STAFF REPORT

CASE #Z-953-19

Request:	PUD Concept Schematic for Prime Sites		
Project Description:	Prime Sites was annexed into the city in 1989 and zoned PUD based on a preliminary plan. This concept schematic is the first step in the process to fully entitle the subject property for future development.		
Discussion Topics:	<ul style="list-style-type: none">• Comprehensive Plan/Future Land Use Plan• Proposed Land Uses• Roadway Configuration• Tower Landfill		
Key Approval Criteria:	None. A PUD Concept Schematic is neither approved nor denied, it is intended to provide feedback to the applicant. Therefore, no formal action is required from the Planning Commission.		
Staff Recommendation:	N/A		
Current Zone District:	PUD (Planned Unit Development District)		
Comp Plan Designation:	Mixed-Use (Corridor and Commercial), Residential - Medium	Office/Flex,	Commercial,

Prime Sites PUD Concept Schematic

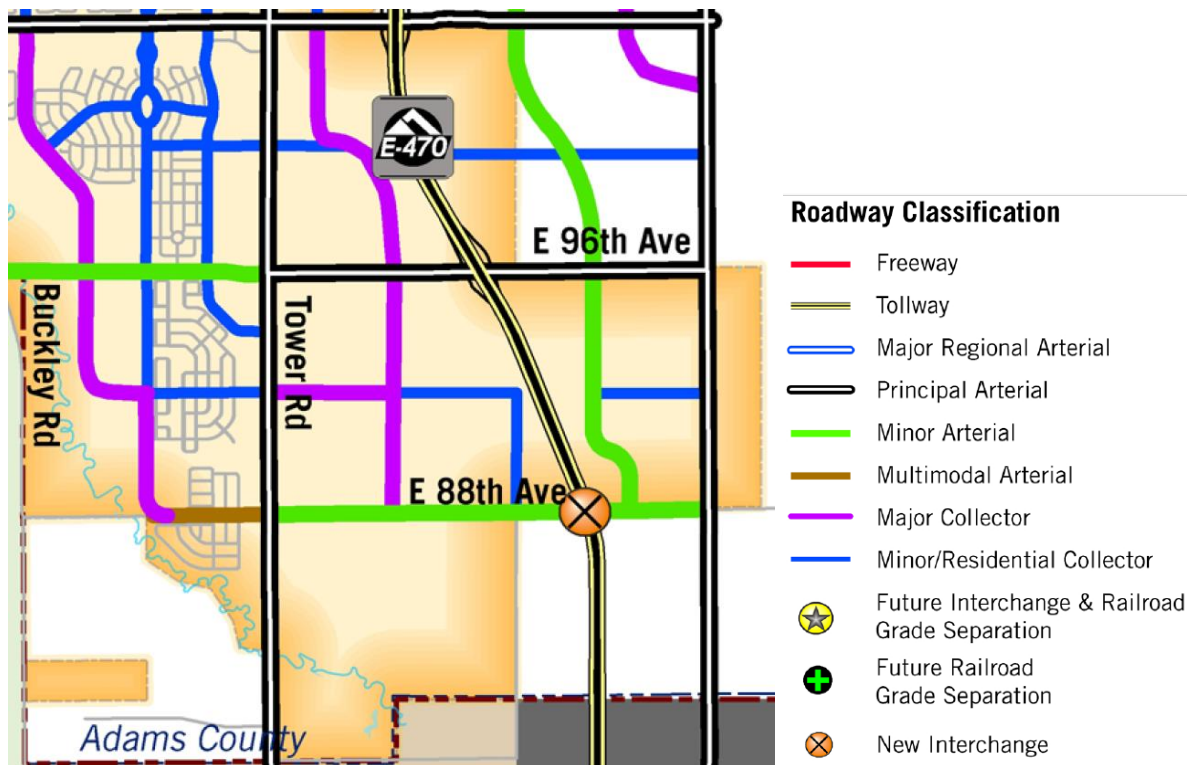
During the review process for the PUD Concept Schematic, Allied Waste provided comments regarding the buffer from Tower Landfill. One of the key comments regarding the proposed land use layout included the request for a 500-foot depth passive buffer (landscape berm with vegetation and no hardscape) along the southern boundary of Prime Sites, and then the 1,000-foot depth Office/Flex land use area to the north of the passive buffer, for a total of 1,500-feet between the landfill and any residential development. Non-residential development within the Office/Flex land use area is requested to be located to the north of that area, with the southern portion reserved for parking and storage types of purposes for an additional buffer for workers. The intent of this 1,500-foot buffer is to alleviate any concerns relating to potential gas and groundwater migration issues and operating concerns related, but not limited to, noise, truck traffic, litter, and dust.

Tri-County Health Department (TCHD) also provided comments pertaining to best practices for development near active landfills. One recommended best management practice is identifying buffer areas for land directly adjacent to the landfill which will experience greater impacts, such as noise, odors, and dust. Identifying these areas within a certain distance of the Tower Landfill could allow the applicant to specify appropriate land uses, transportation corridors, and landscape and topography treatments that will mitigate such impacts. For examples, more compatible uses such as industrial and commercial uses would be allowed in this area with residential and public uses prohibited in order to ensure greater land use compatibility. Another common best practice is the use of berms to reduce noise and dust impacts, which the applicant could make a requirement for landscape area within the buffer area. TCHD also commonly recommends completing a flammable gas investigation plan for any new development located within 1,000 feet of landfills since flammable gases from decomposing organic matter can migrate underground from the source.

As currently proposed, the PUD Concept Schematic shows an approximately 900-foot depth from East 88th Avenue for the Office/Flex land use area, which could contain such uses as offices, flex space, light industrial and high tech uses, with supporting commercial uses including retail, restaurants, and hotels. Combined with the required 120 feet right-of-way for East 88th Avenue and 80 feet of right-of-way for a major collector separating the Office/Flex and Residential land use areas, and the total distance separation from Tower Landfill to the nearest residential use would be approximately 1,100 feet. The concept schematic also includes notes regarding the buffer, stating that enhanced landscaping will be required along East 88th Avenue and that buildings in the Office/Flex land use area will be encouraged to be closer to the internal roadways with parking areas along East 88th Avenue.
